## ASSESSMENT REPORT

### MIXED-USE DEVELOPMENT, KIRRAWEE BRICK PIT MP 10\_0076 MOD 8

On 28 February 2017, the Proponent lodged a section 75W modification request (MP 10\_0076 MOD 8) seeking approval to remove the requirement to provide a lake within the public park. The removal of the lake would provide additional useable space for the community.

Figure 3: Proposed Areas of STIF Regeneration.

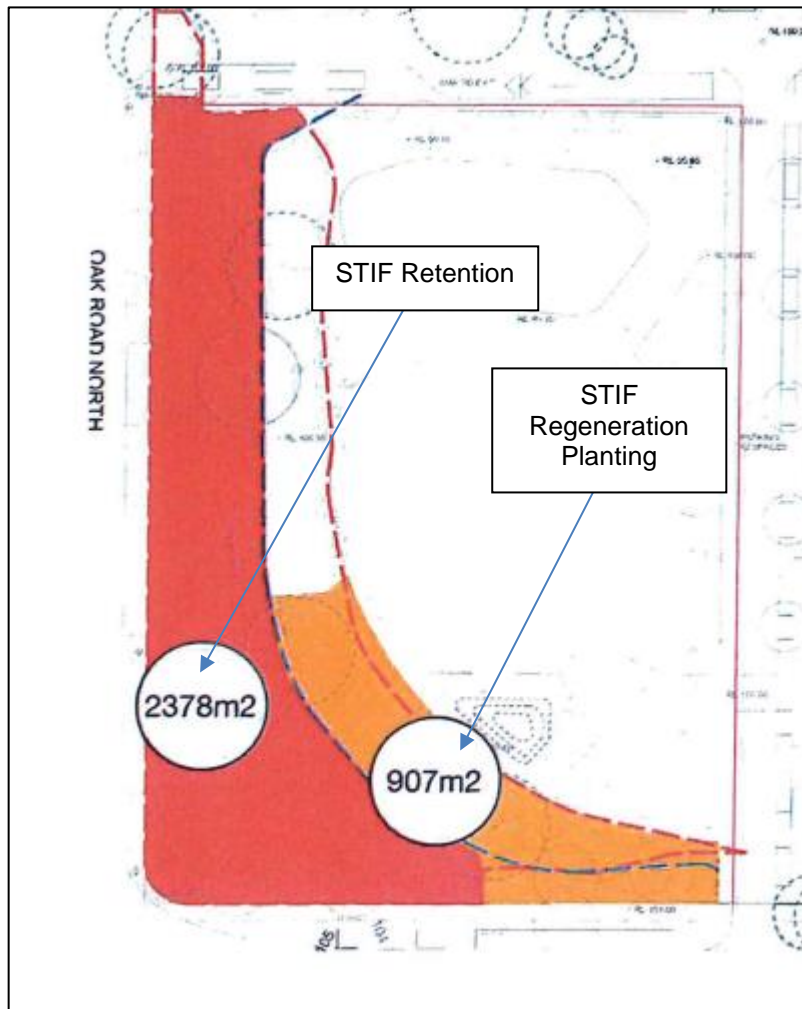
MOD 3 requires 907 m<sup>2</sup> of STIF regeneration within a consolidated area of the park, shown in **Figure 2**. The proposal seeks to amend the regeneration area and plant 944 m<sup>2</sup> of STIF across five separate sites as shown in **Figure 3**.

While the proposal exceeds the total amount of STIF required to be planted on the site, OEH raised concern that certain areas (C and D) are sub-optimal from a conservation perspective, as they have a high perimeter to area ratio, and are isolated from the existing STIF. OEH raised concern that these areas should not be included in the total area of STIF regeneration.

The Department notes OEH's concerns about the location of Areas C and D of regenerating STIF and accepts that these areas should not be included in the calculation towards the required 907 m<sup>2</sup> of STIF regeneration.

- identified possible areas for an additional 800 m<sup>2</sup> of STIF regeneration as a result of the removal of the lake (see **Figure 4**)
- noted Areas C and D are located to provide a visual buffer, and that the majority of regenerating STIF is within proximity to existing STIF
- noted that with the increased density approved on the site, the demand for recreation facilities has increased, making it difficult to provide contiguous areas of STIF.

However, the Department considers the proposal (excluding Areas C and D from calculations) would still provide an acceptable outcome, as:

- the inclusion of the 800 m<sup>2</sup> would ensure the total amount of STIF regeneration on the site (excluding Areas C and D) is still 646 m<sup>2</sup> more than that approved under MOD 3
- the 800 m<sup>2</sup> of additional STIF would be located so that it is contiguous with existing STIF
- a visual buffer would be provided between the park and the development through the retention of Areas C and D.

The Department considers the proposal would result in an acceptable outcome as the total amount of STIF to be regenerated on the site would increase by 20% compared to the original approval. The Department has also recommended a condition requiring the 800 m<sup>2</sup> of additional STIF to be located generally in accordance with the plan provided (**Figure 4**), or as otherwise agreed to in writing by OEH.

In response, the Proponent provided an amended plan showing the deletion of the boardwalk within the south-eastern corner of the park (shown in **Figure 4**), allowing for the retention of 115 m<sup>2</sup> of STIF to offset the 112 m<sup>2</sup> removed for the roadworks. The Proponent also noted the off-site offsets were increased to compensate for the road widening STIF removal (see **Appendix A**).

OEH supports the proposed removal of the board walk to provide an additional 115 m<sup>2</sup> of STIF retention on the site, to compensate for that removed due to the road widening.
